FLOODWATER RETARDING DAM NO. 2 SANDERSON CANYON WATERSHED PROJECT BREWSTER, PECOS AND TERRELL COUNTIES, TEXAS

AS BUILT PLANS
CONTRACT NO. 50-74-42-3-2607
CONTRACTOR J. D. Abrams, Inc.
CONSTRUCTION COMMENCED 9/27/83
GOV. REPRESENTATIVE Billy J. Gunter
GOV. INSPECTOR Cyril W. Hamilton
BID PRICE 4,876,079.74
FINAL PRICE 5,735,346.24
CONSTRUCTION COMPLETED 4/2/87

Drawing No.
4-E-36,851

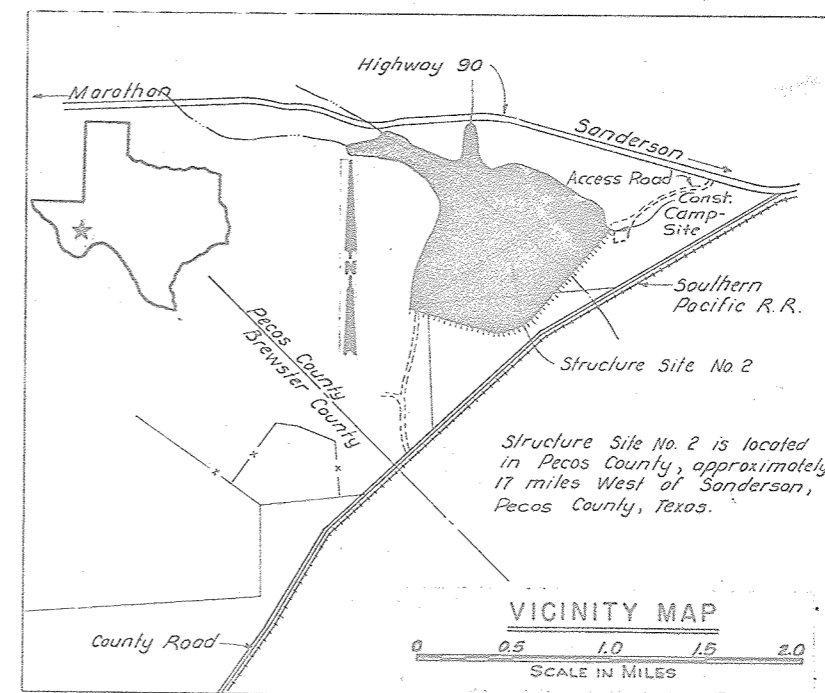
DRAINAGE AREA 34,067 ACRES
TOTAL STORAGE 5,990 AC.FT.
HEIGHT OF DAM 56 FEET
VOLUME OF FILL ~~1,987,838~~ 2,328,464 CU. YDS.

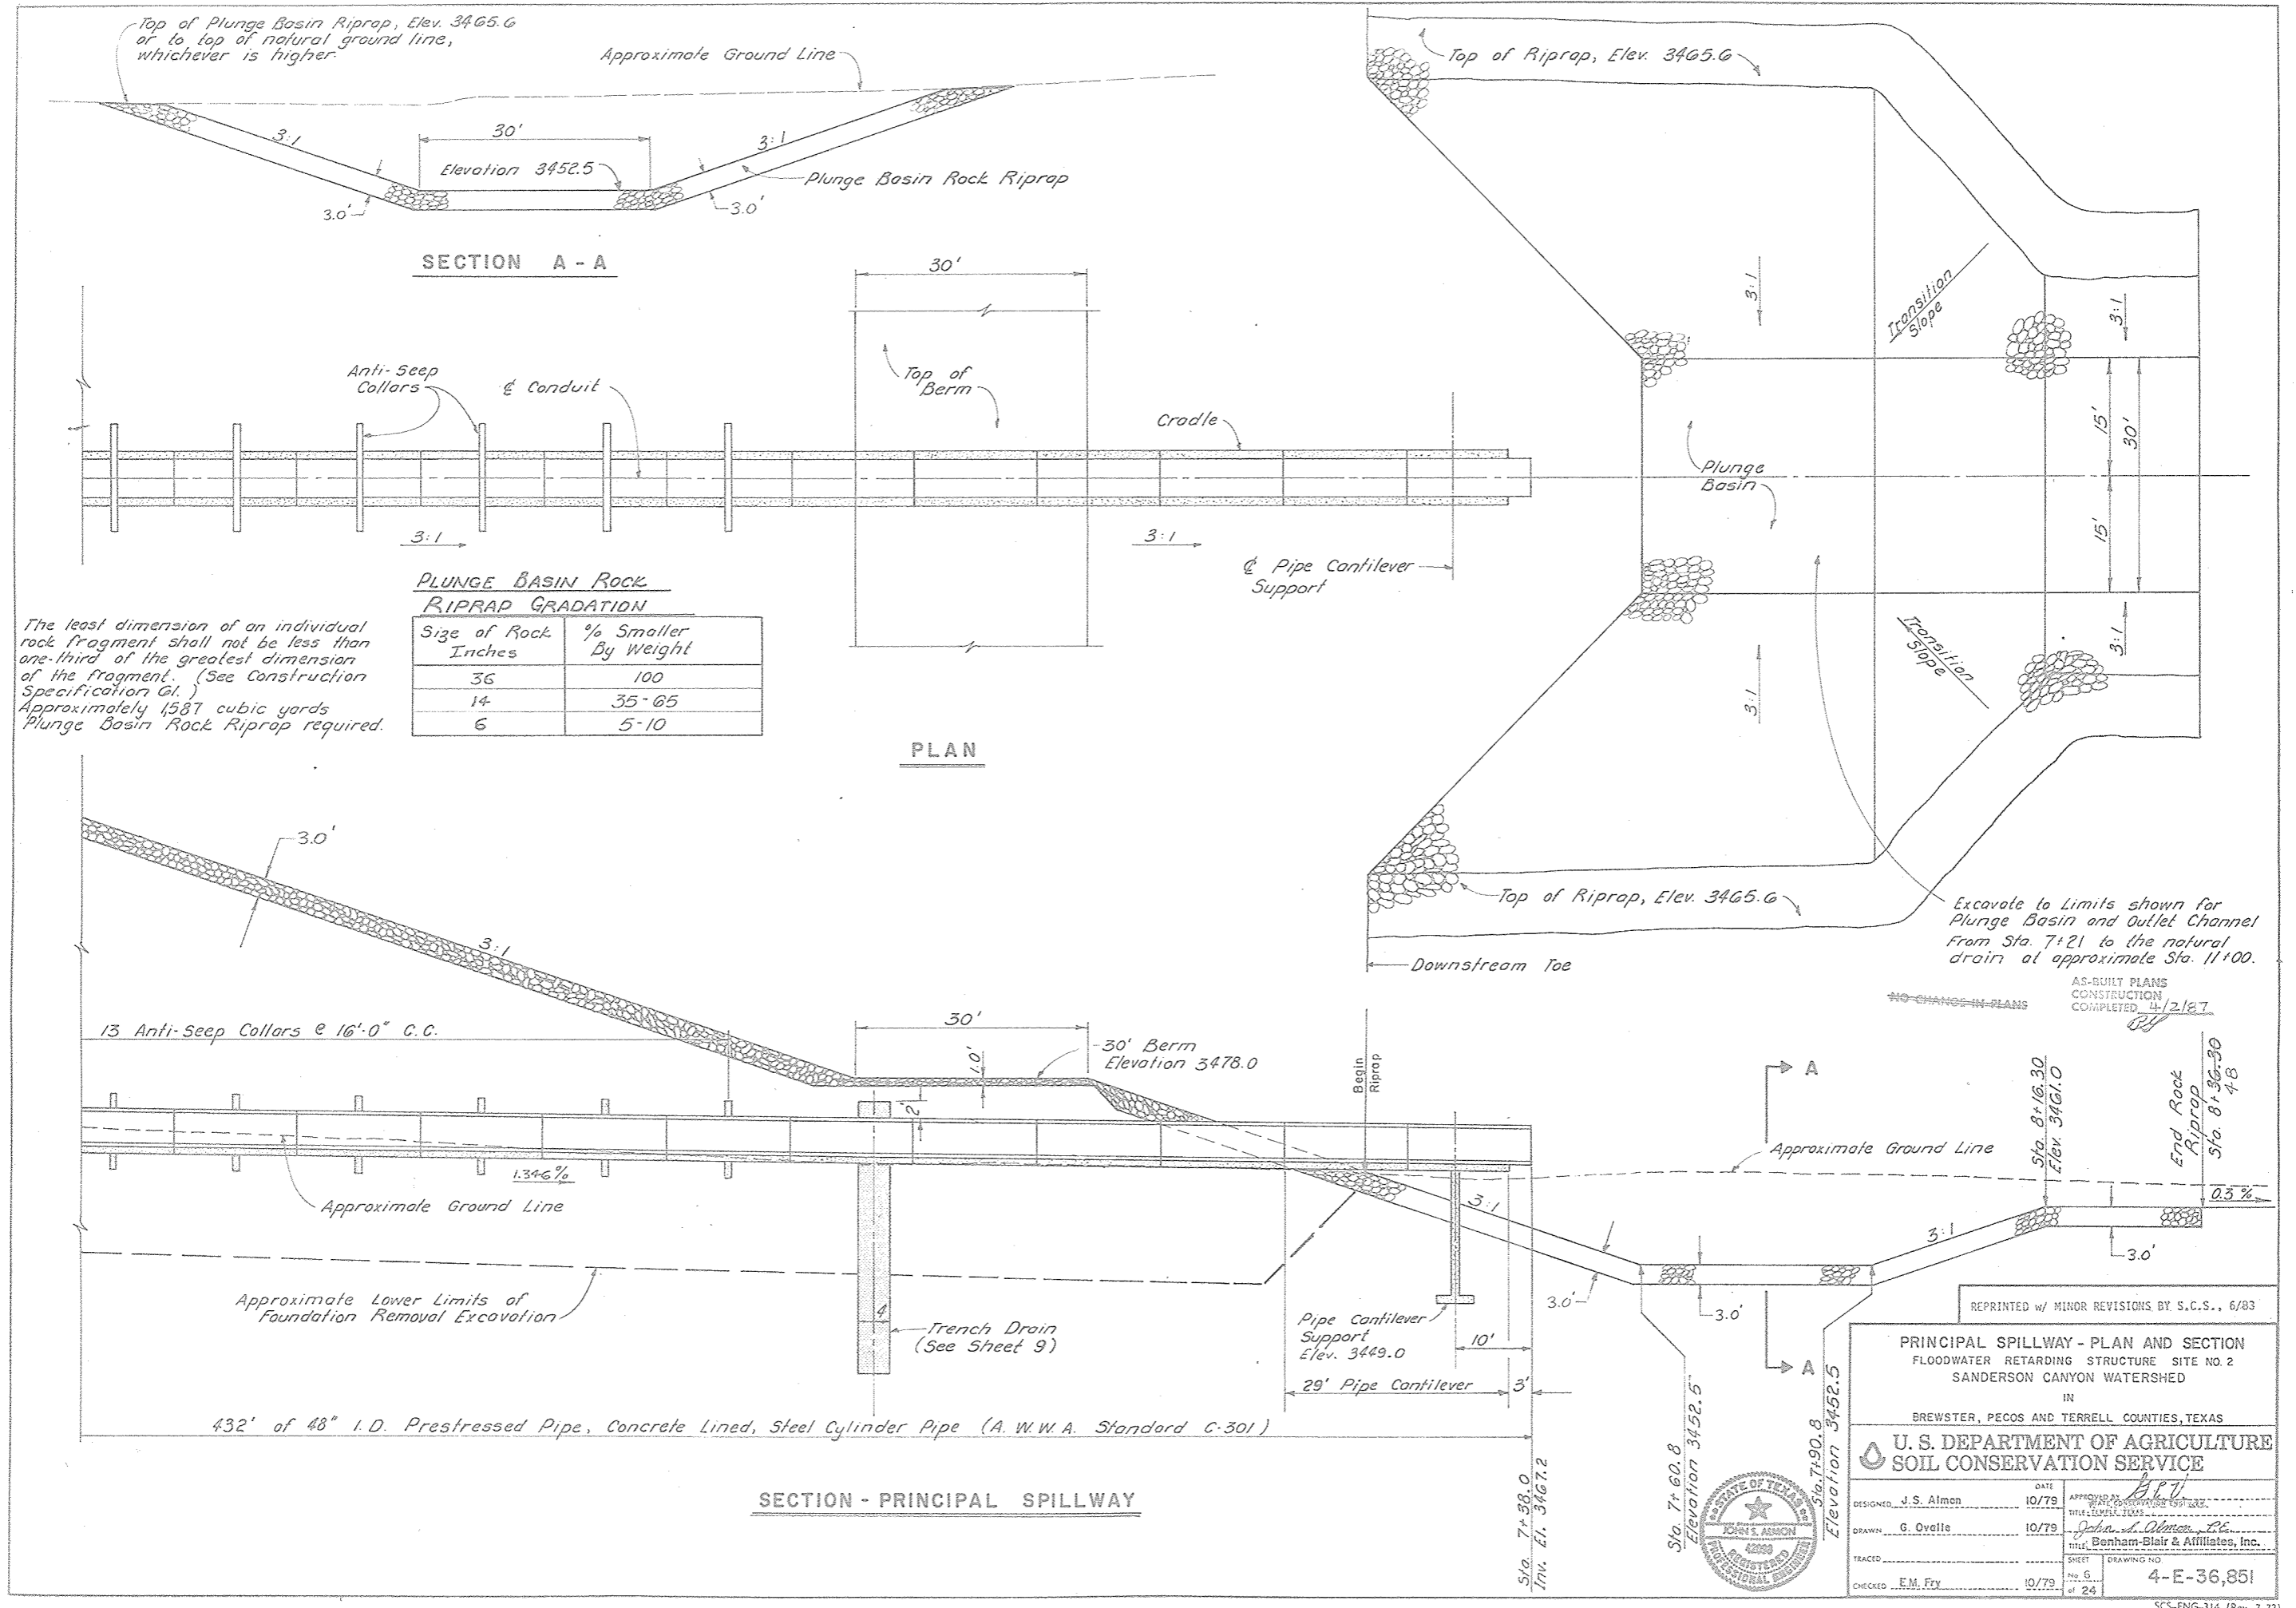
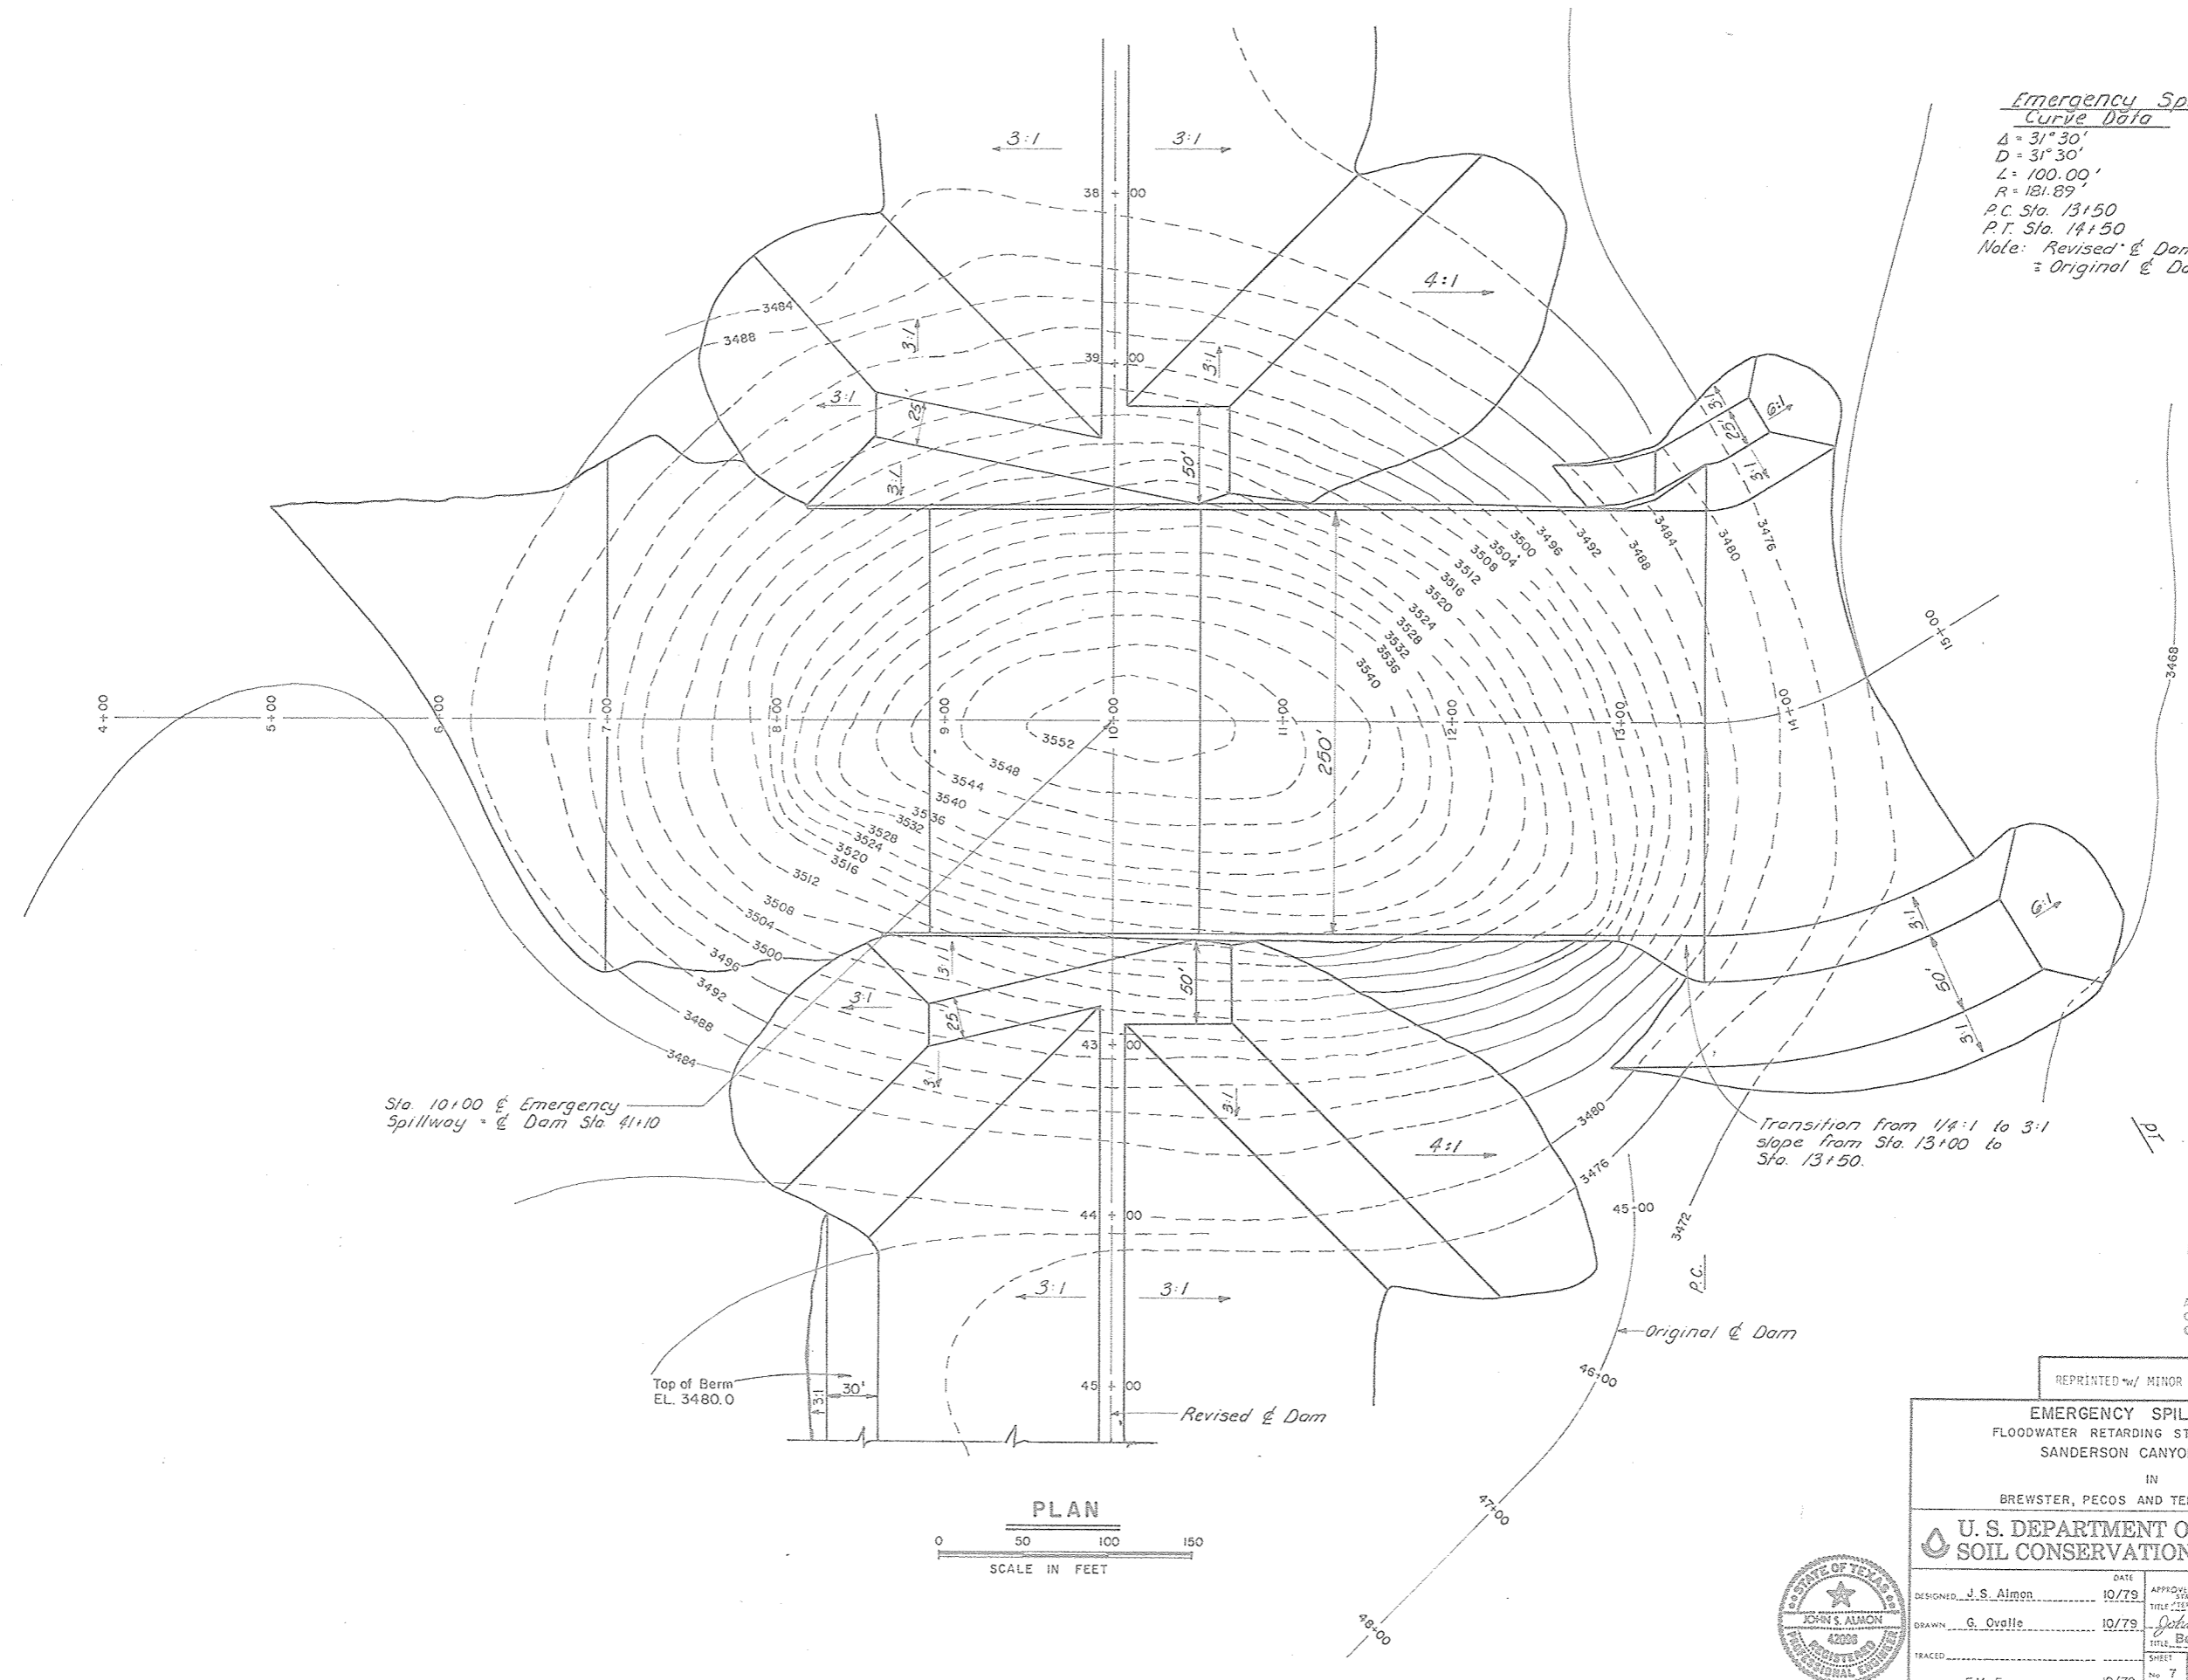
$\Delta = 31^\circ 30'$
 $D = 31^\circ 30'$
 $L = 100.00'$
 $R = 181.89'$
 P.C. Sta. 13+50
 P.T. Sta. 14+50
 Note: Revised $\&$ Dam Sta. 51+43.94
 Original $\&$ Dam Sta. 53+83.90

Revised $\&$ Dam

Original $\&$ Dam
